PCN# 20130514000

Correct Notch Alignment on

MityARM-335X Family System on Modules

Date: May 14, 2013
To: Purchasing Agents

Figure 1 PCB 90-000166R-5A Drawing Update for Notch Alignment

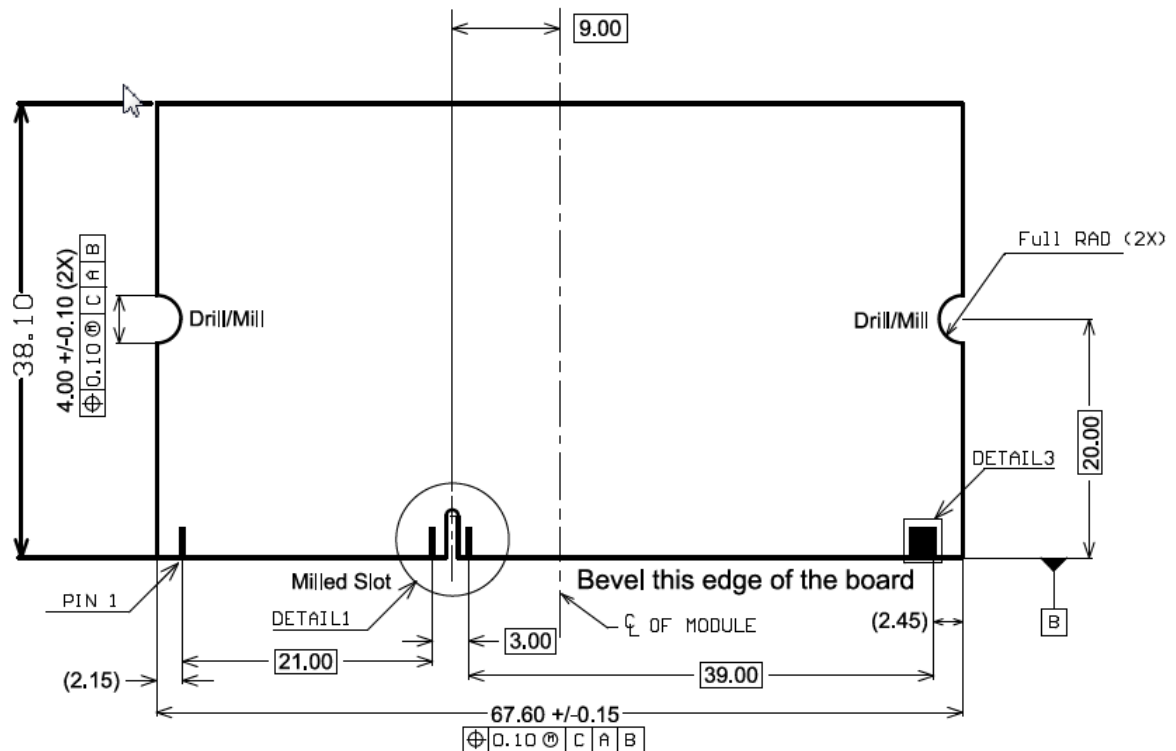
The PCB fabrication drawing was updated to provide tighter tolerance on location of center notch. In addition, a general cleanup of the drawings was also performed.

Analysis of production yield revealed misalignment of UUT edge connector with the test fixture connector was causing board test failures.
